**Eugene School District 4J
ROOSEVELT MIDDLE SCHOOL**
680 East 24th Avenue
Eugene, OR 97405
CIP No. 410.566.001

ADDENDUM NO. 6

This Addendum forms a part of the Contract Documents and modifies the original Bidding Documents dated February 18, 2015 and subsequent addenda as noted below. Acknowledge receipt of this Addendum in the space provided on the Bid Form. Failure to do so may subject the Bidder to disqualification.

A1 MECHANICAL EQUIPMENT PLATFORM PLAN - ZONE A WEST- MECHANICAL
1/4" = 1'-0"

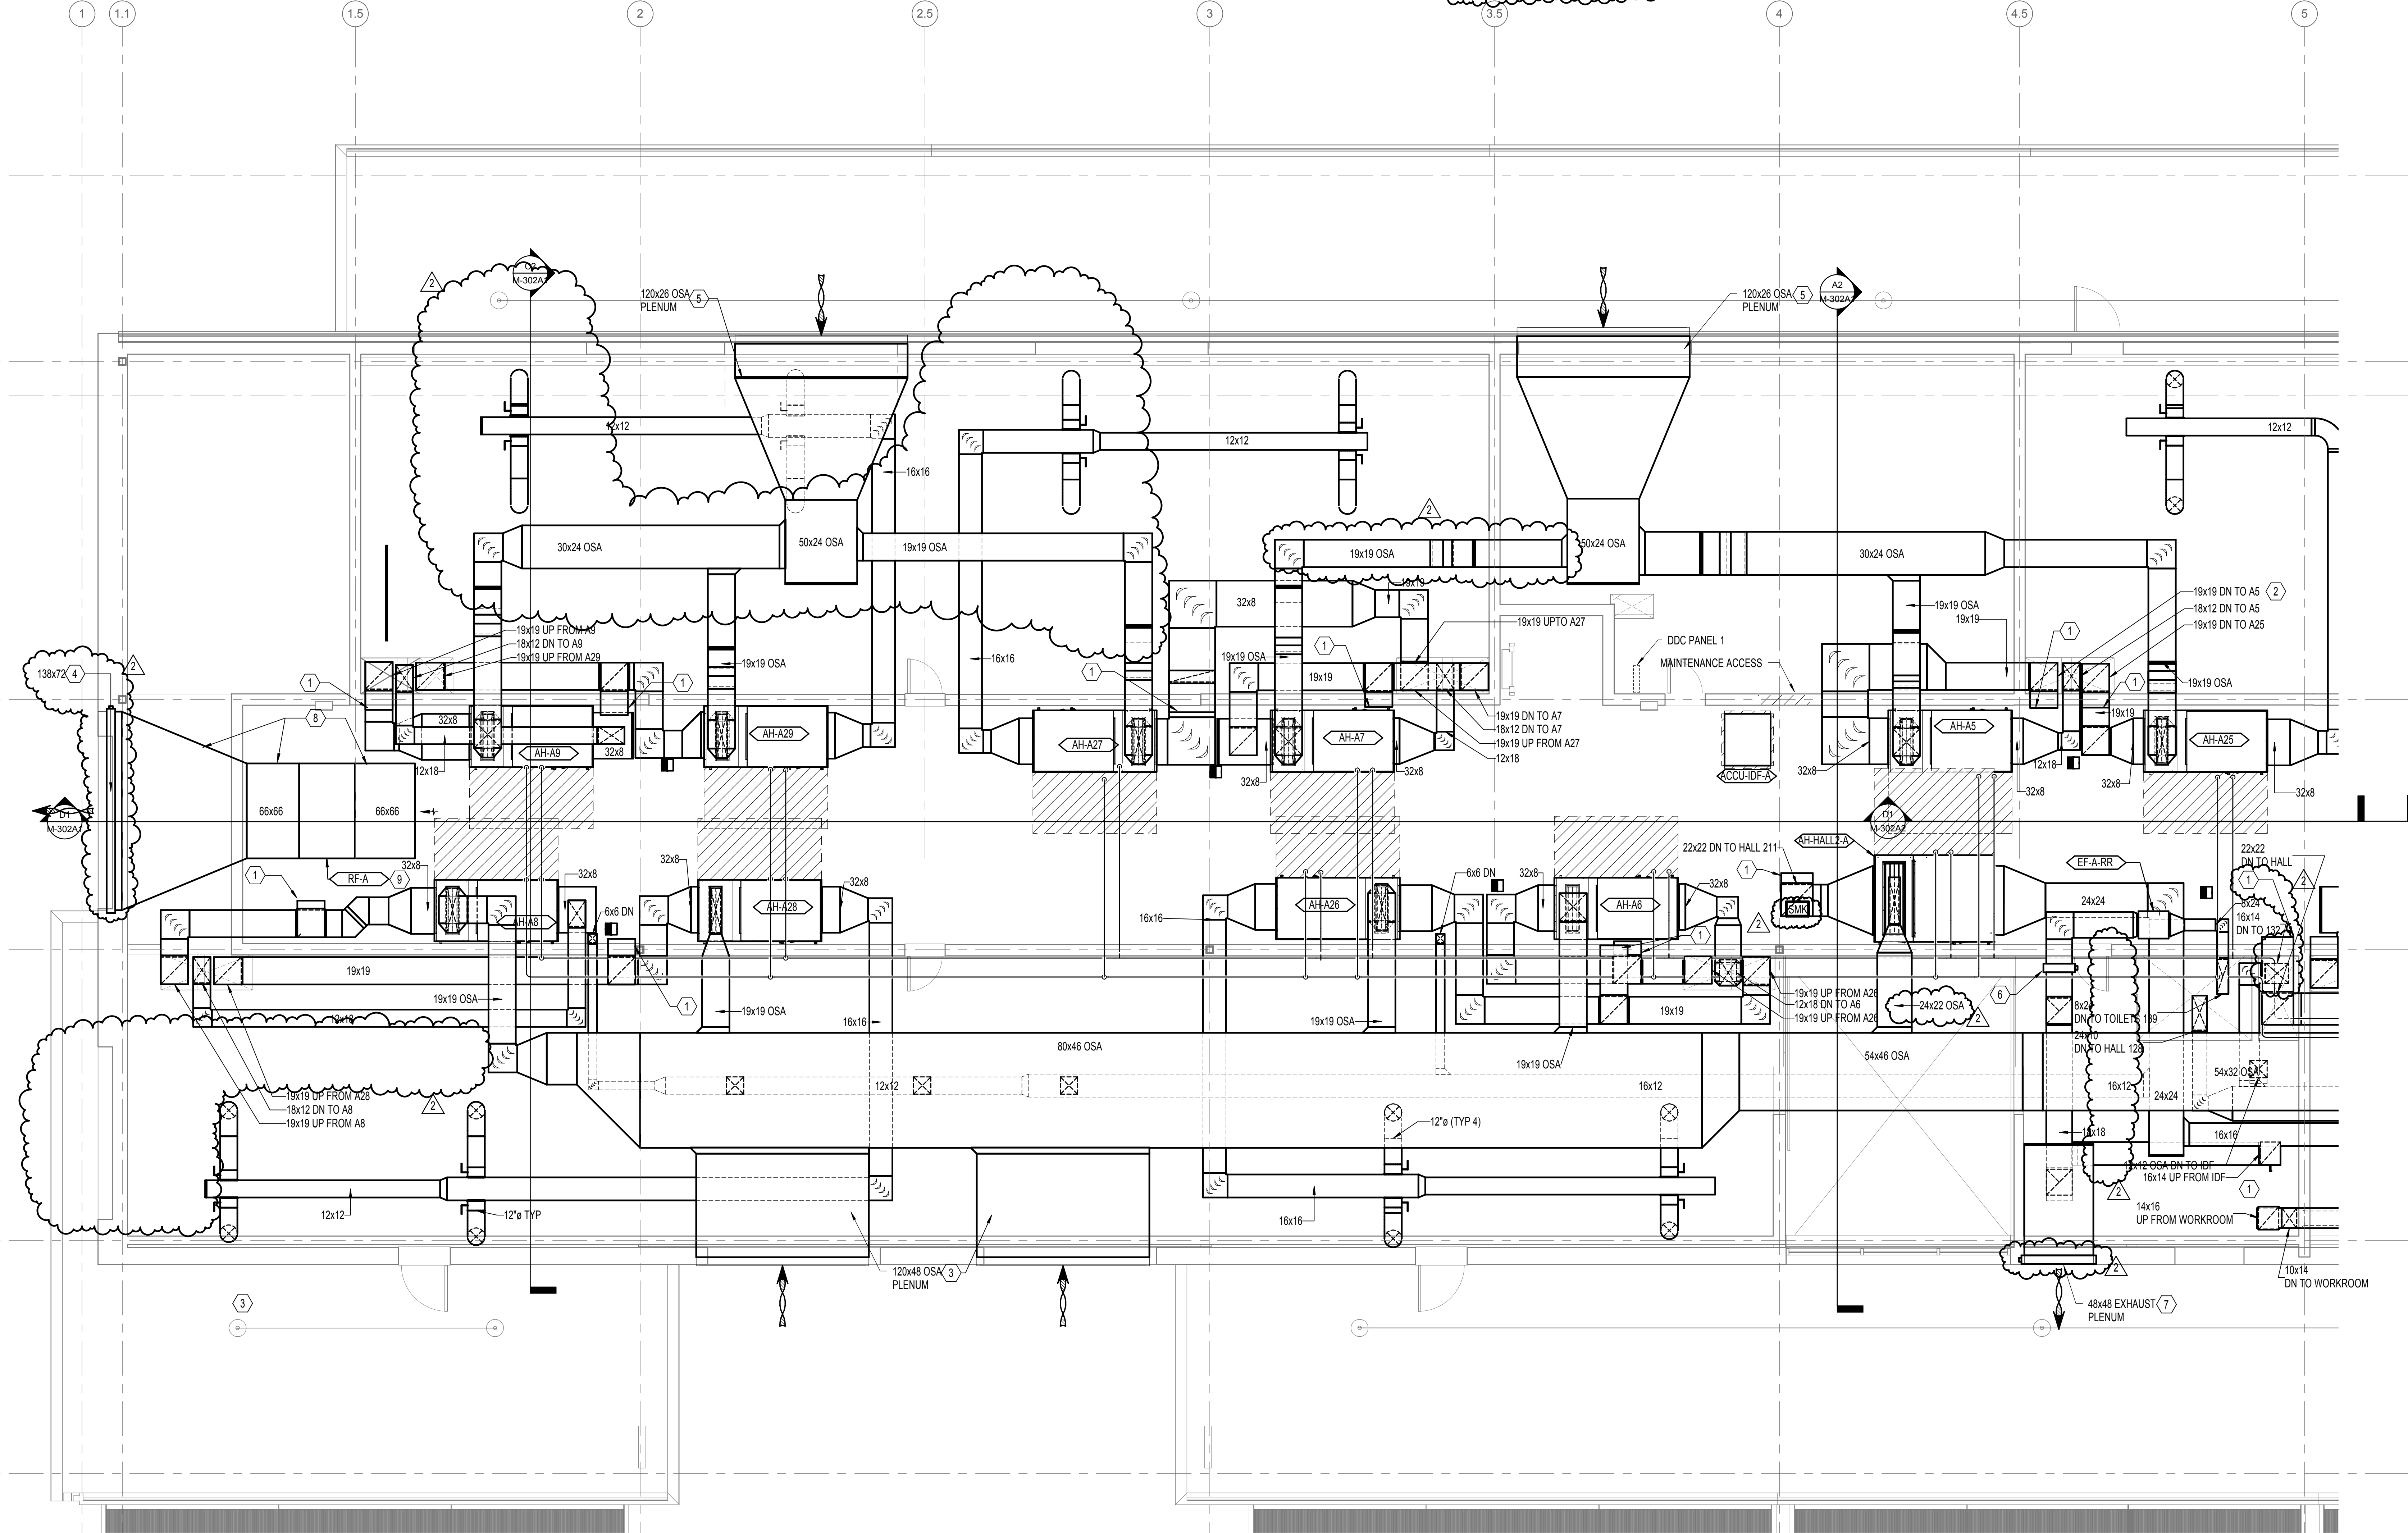
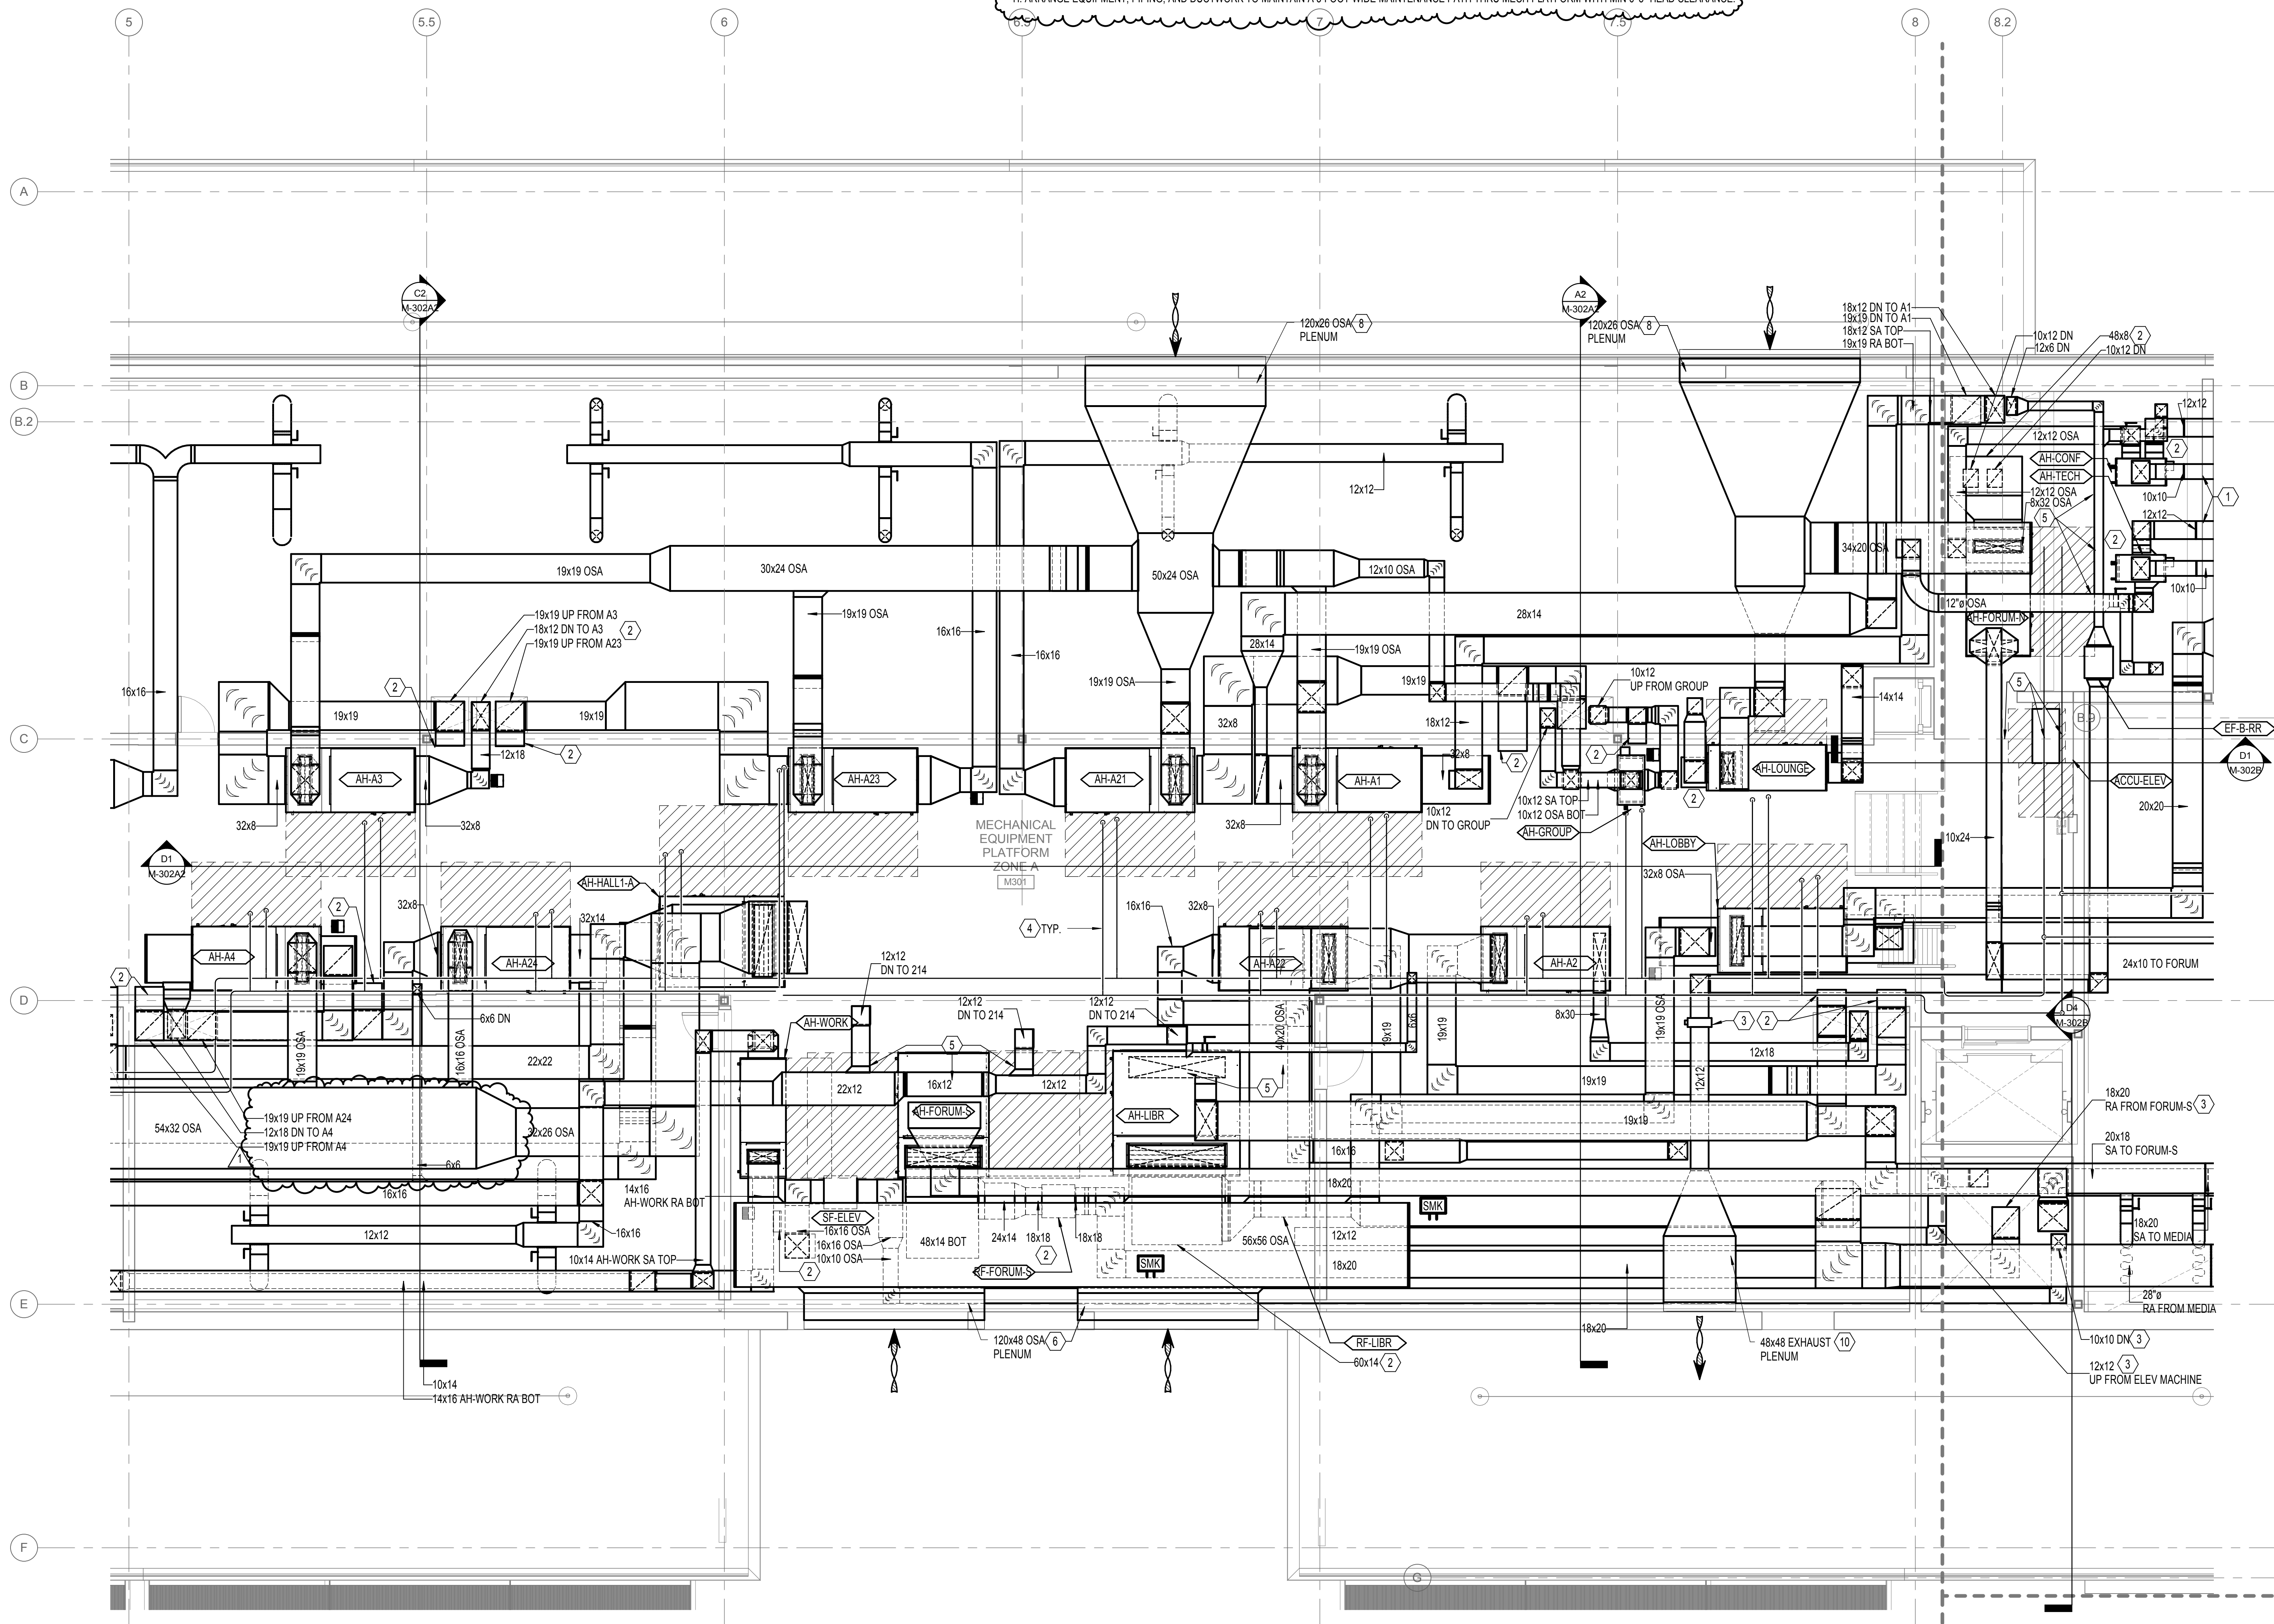
- A. Replace Sheet with revised Sheet M-401A1: Delete osa intake plenum and ductwork at west and north walls. Clarify relief damper requirements at RF-A. Add auto damper to exhaust plenum at south wall. Revise exhaust duct routing from IDF room. Add relief dampers to AH-HALL1-A. Revise osa duct size and add smoke detector at AH-HALL2-A. Add general note regarding walking path width and head room requirement.

A1 DUAL TEMPERATURE WATER SYSTEM DIAGRAM
NONE

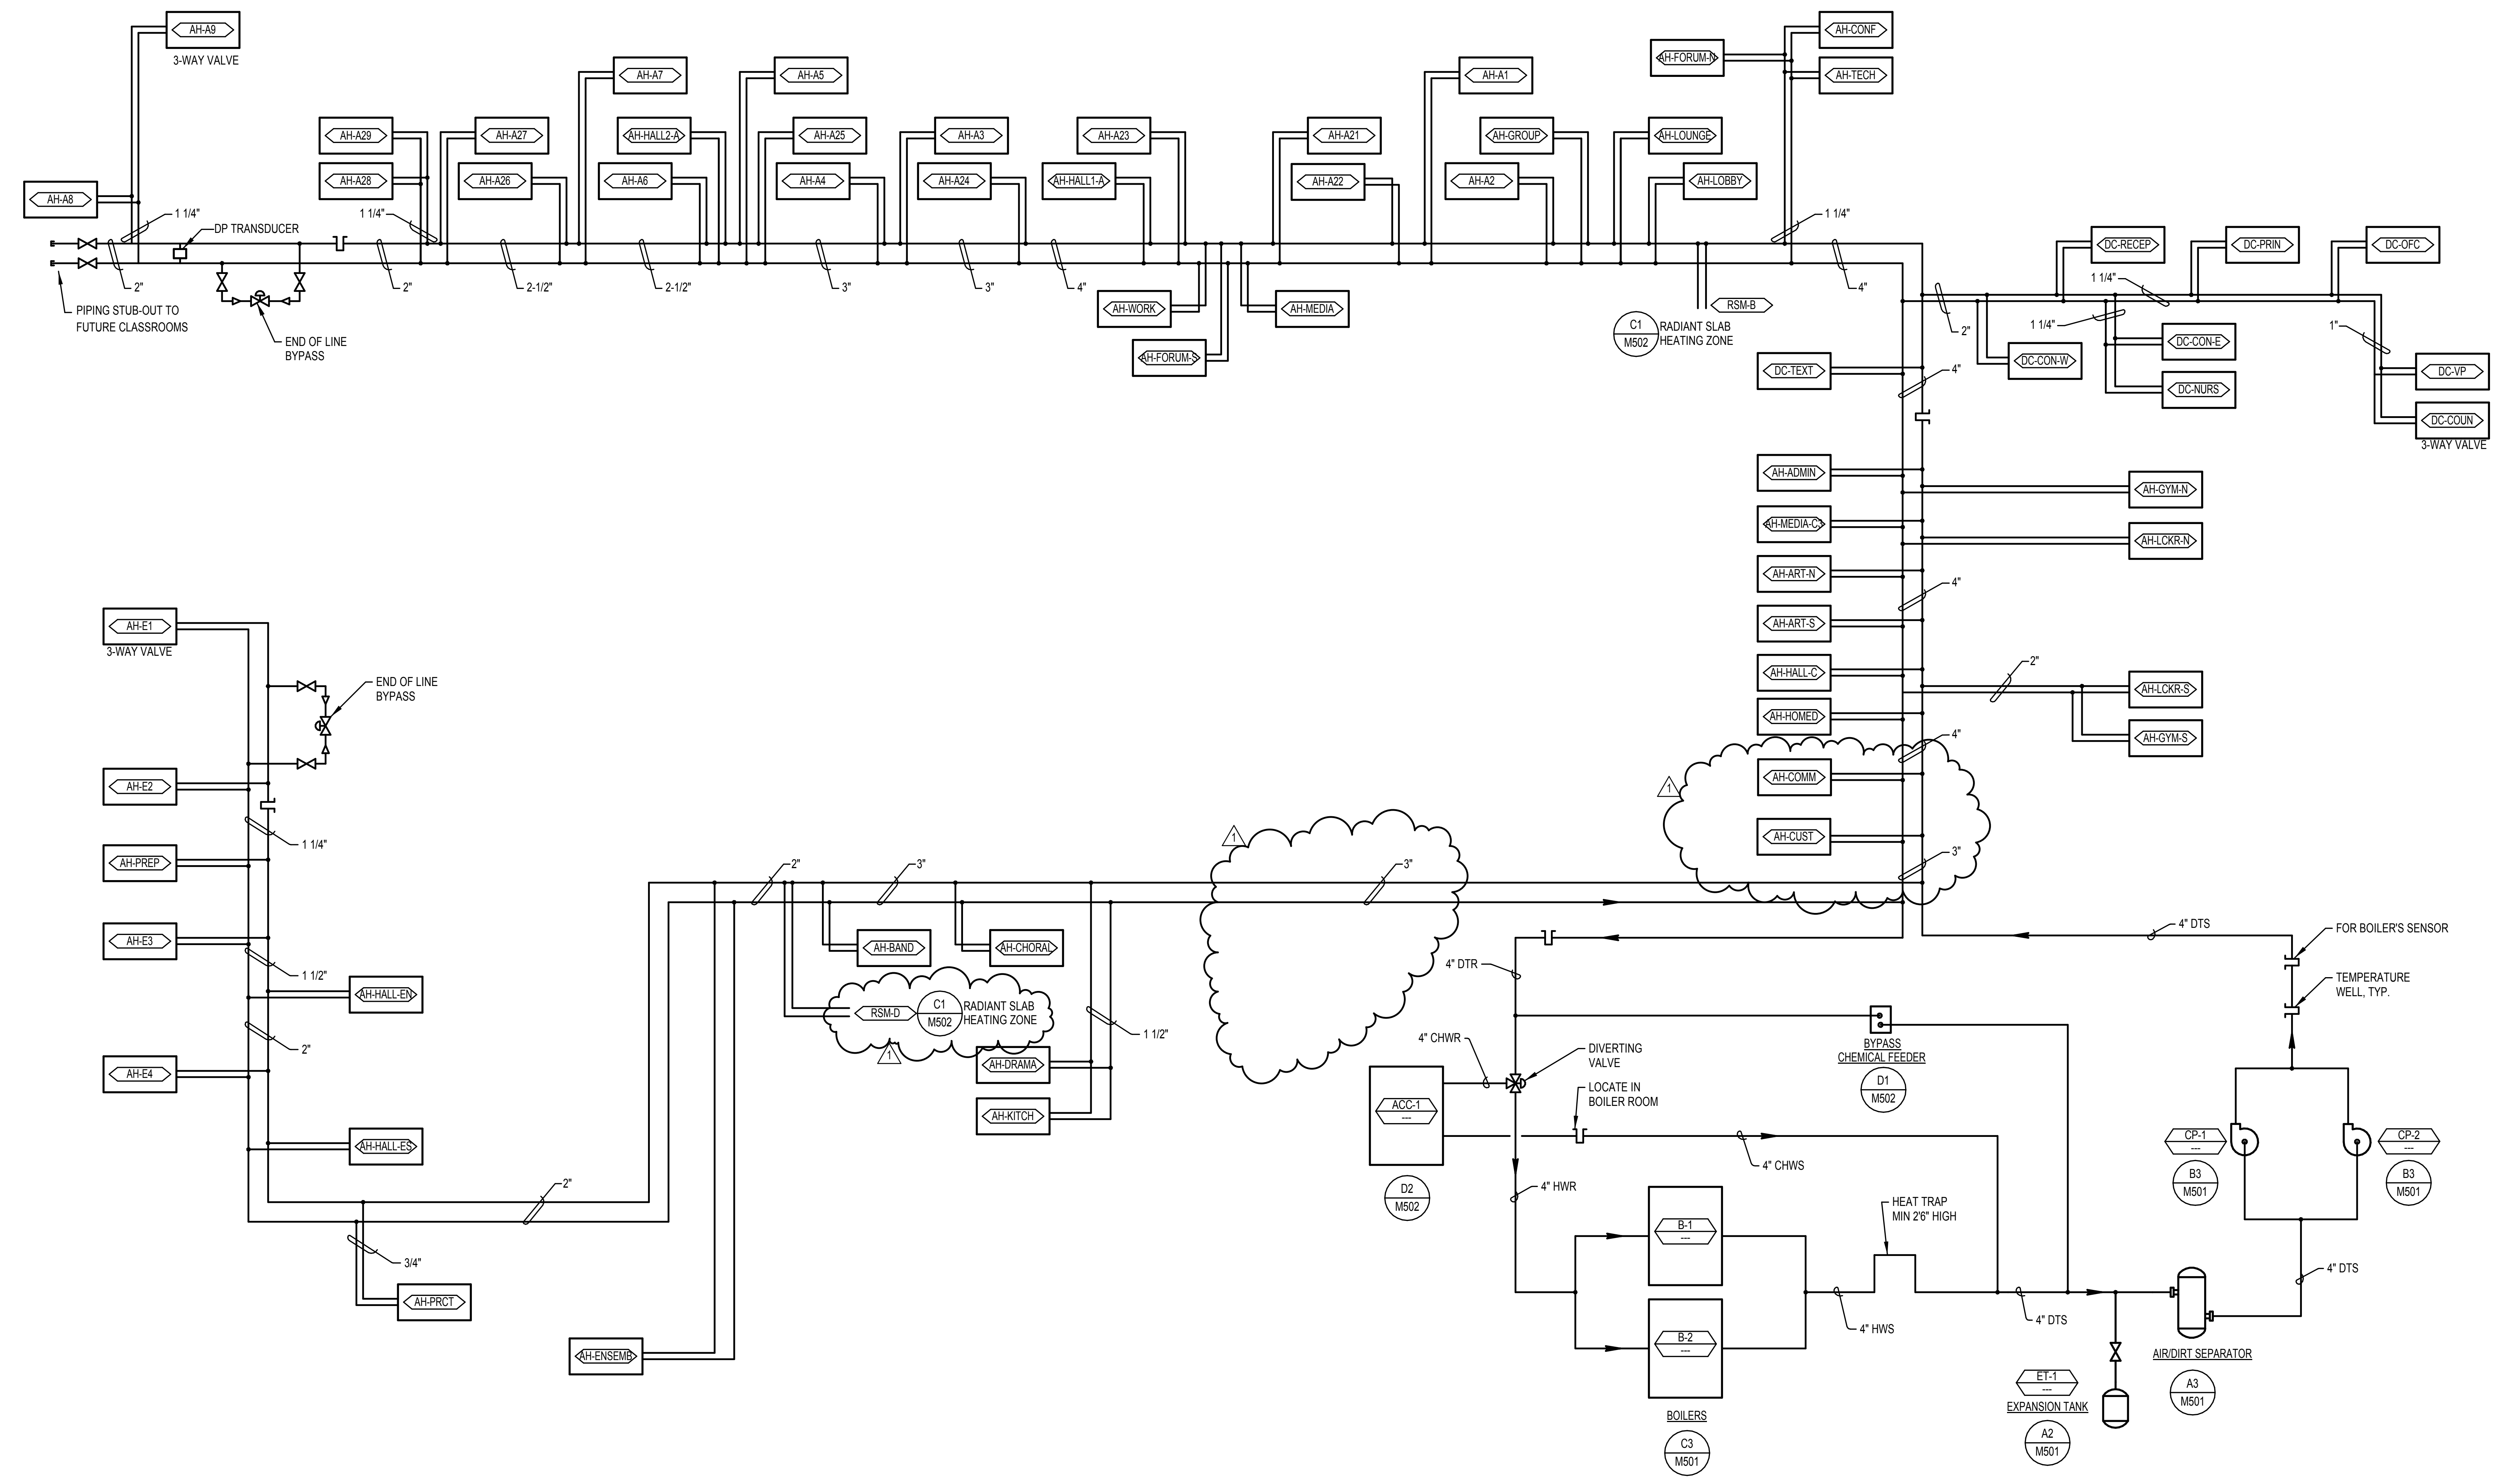
114. SHEET M-601 DIAGRAMS - MECHANICAL
- A. Replace Sheet with revised Sheet M-601: Revise location of units and pipe sizes.
115. SHEET E-002 LUMINAIRE SCHEDULE
